| APPROVALS | | DATE | | TITLE: SERVICE BULLETIN WSB IDU-III-17 (IDU LIMITS DIGITAL GAIN MODIFICATION) | |

SERVICE BULLETIN

EQUIPMENT: IDU-III

BULLETIN NUMBER: WSB IDU-III-17 Revision A

Figure 3 System User Programmed Settings (Page 1)

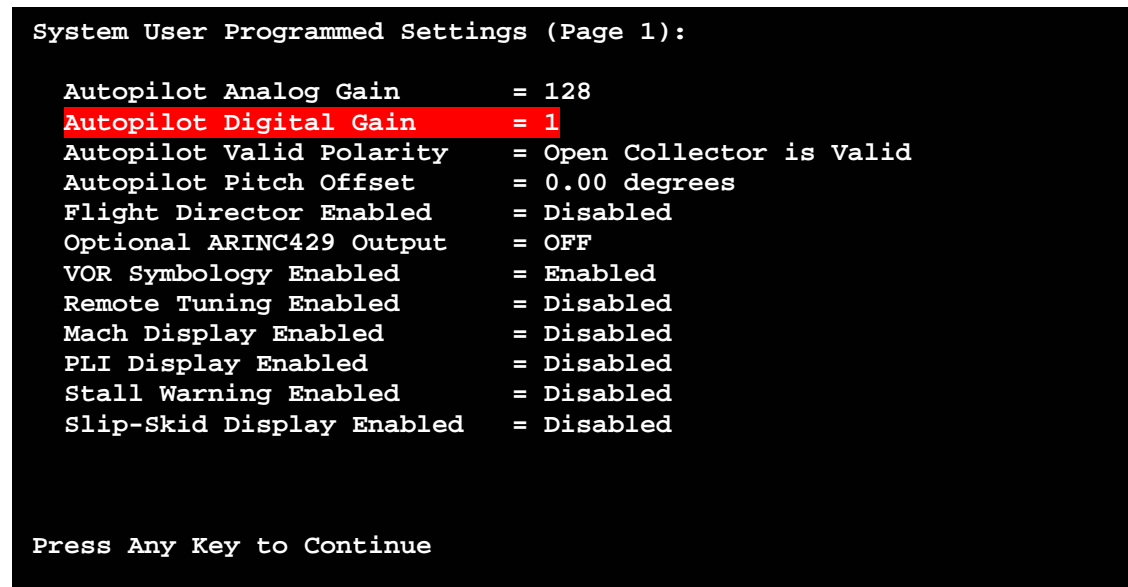
6. Press any button or rotate the right-hand encoder three (3) times until the “System User Programmed Settings (Page 1)” is displayed.
7. View the *Autopilot Digital Gain* option (As shown in red in Figure 3).

8. If the *Autopilot Digital Gain* option displays a value other than “1”, proceed with the Modification Procedure in this Service Bulletin.

NOTE: *If the Autopilot Digital Gain option displays a value of “1”, this Service Bulletin is not applicable.*

Figure 4 Update Databases, Limits and Applications

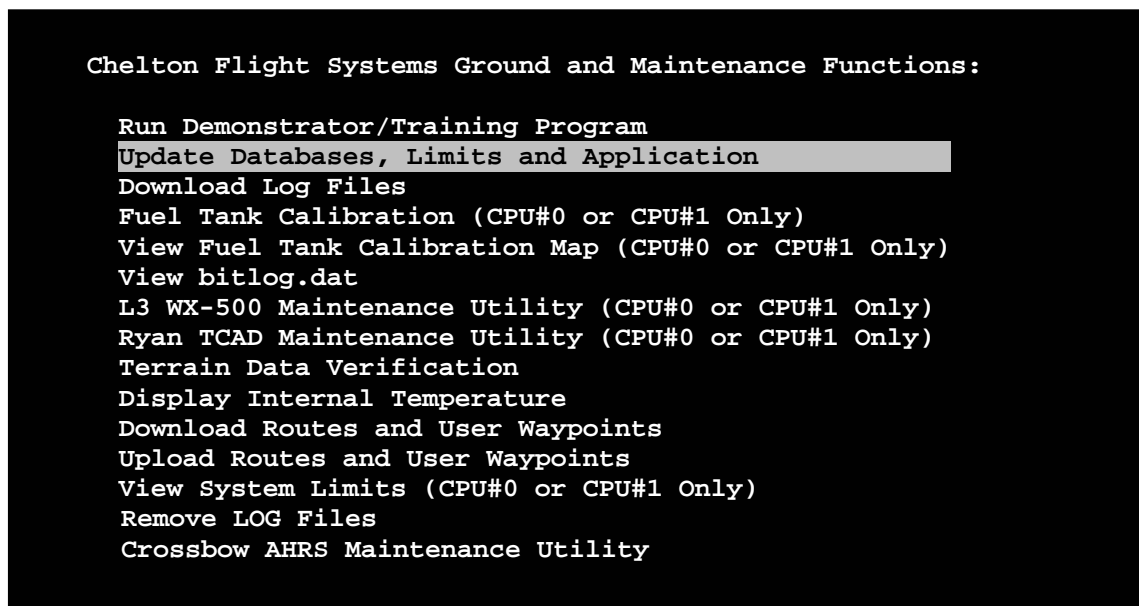
6. Rotate the right-hand encoder until the “Update Databases, Limits and Application” is highlighted then press in the right-hand encoder (See Figure 4).

Figure 5 Typical SCC Programming

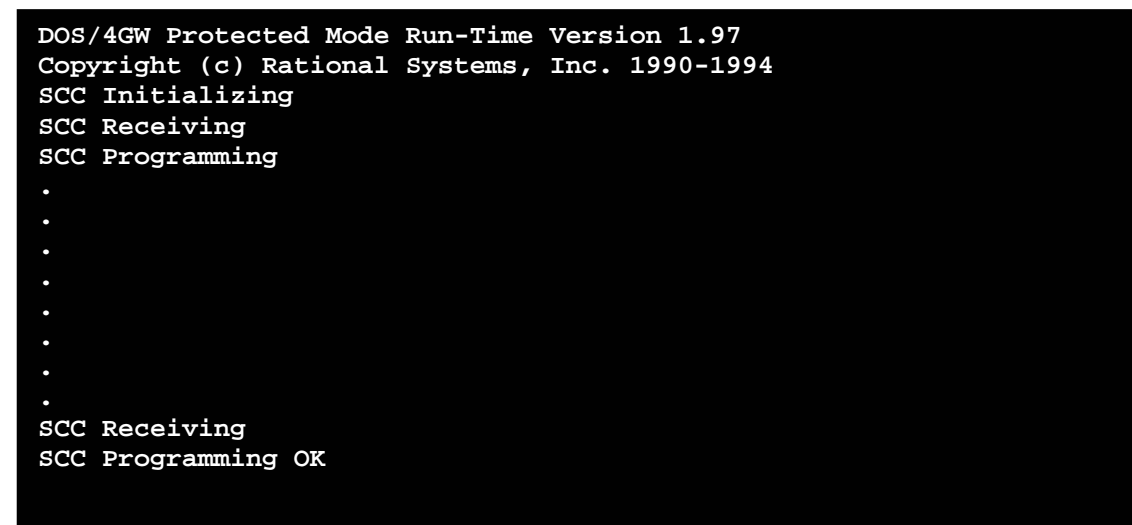
7. Verify the System Configuration Card programming is completed (See Figure 5).

NOTE: Upon completion of the SCC Programming, the IDU will perform a “Scandisk” of both internal drives then return to the Ground Maintenance menu.
